ARM  
L220 Level 2 Cache Controller (AC131)  
**Errata Notice**

This document contains all errata known at the date of issue in releases up to and including revision r1p7 of L220

**Figure 1: Implementation workaround for 401552 erratum when the L220 MBIST interface is used**

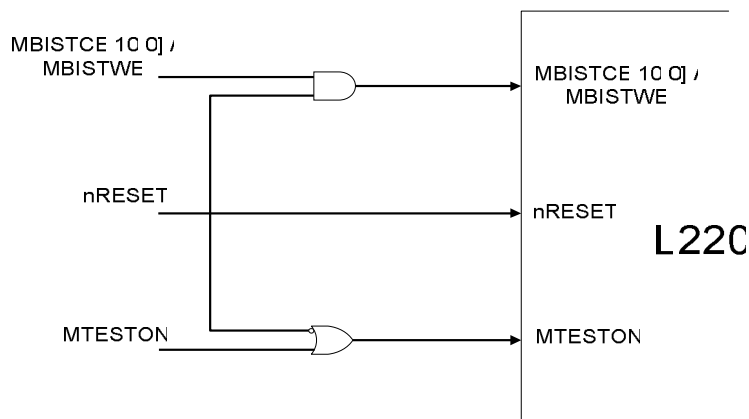
The registers mbist\_ce\_reg[10:0] and mbist\_we\_reg declared in the L220\_bist\_if.v verilog file are not reset. As a result, they have an unknown value (1'bX in simulation, VDD or VSS on silicon) after the L220 cache controller has been reset. However, the output of these registers is used to control some RAM output signals in L220\_cache\_ctl.v, even if the MBIST mode is not enabled (i.e. in functional mode).

On silicon, the value of uninitialised registers is unpredictable. If the output of the mbist\_ce\_reg[10:0] and mbist\_we\_reg registers is not VSS when the power is turned on, failures (incorrect values driven to the RAMs) occur in functional mode. Under these circumstances, this means that L220 cannot be enabled.

There is one possible workaround for this erratum. Before L220 is enabled, e.g. during the reset sequence of L220 (nRESET asserted LOW), MTESTON can be driven HIGH for at least one clock cycle while MBISTCE[10:0] and MBISTWE are driven LOW. This allows propagating known and inactive values to the output of the mbist\_ce\_reg[10:0] and mbist\_we\_reg registers.

- if the L220 MBIST interface is used

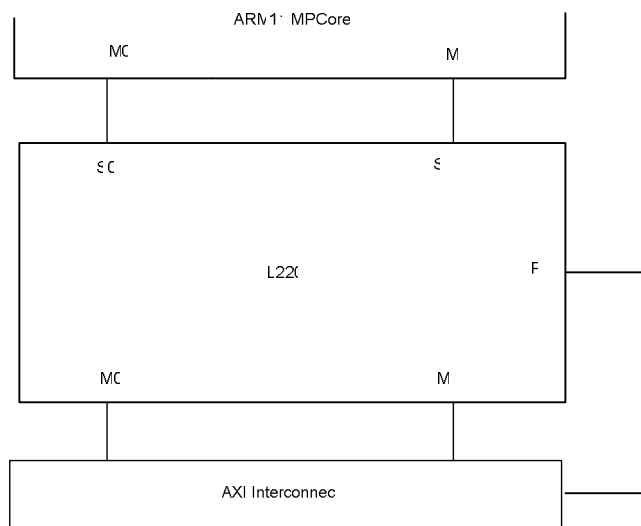
Certain L2 cache maintenance operations and accesses to the Peripheral port only start when the L220 Write Buffer is empty. Their corresponding write response is only sent on AXI when the operation is complete or the access has taken effect.

A deadlock can occur if the Write Buffer is not empty when such an operation or access is received by the L220 Peripheral port.

The problem occurs when the following conditions are met:

1. The Core and L220 are implemented in a system using a similar connectivity as described in section 1.3 of the L220 TRM.
2. The L220 Write Buffer is not empty and contains valid data that needs to be sent to L3 (eg. non-cacheable or write-through or write-back miss no write-allocate).

**Figure 3: Implementation workaround for 391290 erratum**

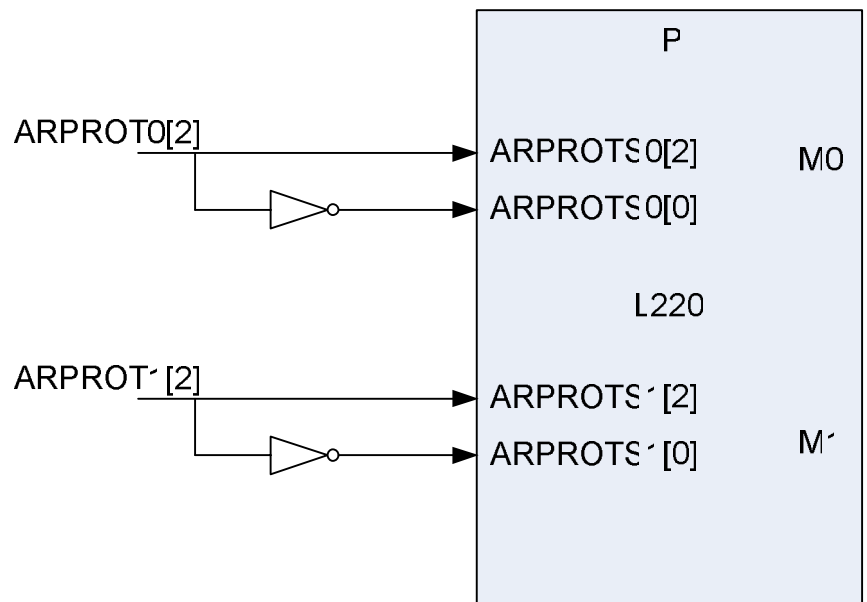
## **391290: The L220 does not make correct distinction between data and instructions for cache lockdown**

There is a possible implementation workaround for this erratum. Indeed,  $ARPROT[0]$  indicates if the read transaction is normal or privileged. This information is not used within L220 and can only be relied upon at L3 level in case of Strongly Ordered or Device accesses. If  $ARPROT[0]$  is not used by the L3 memory system in that context, it is possible to workaround the erratum described above by connecting  $ARPROT[2]$  to the  $ARPROT[0]$  input on the L220 slave ports, as described in the figure below.
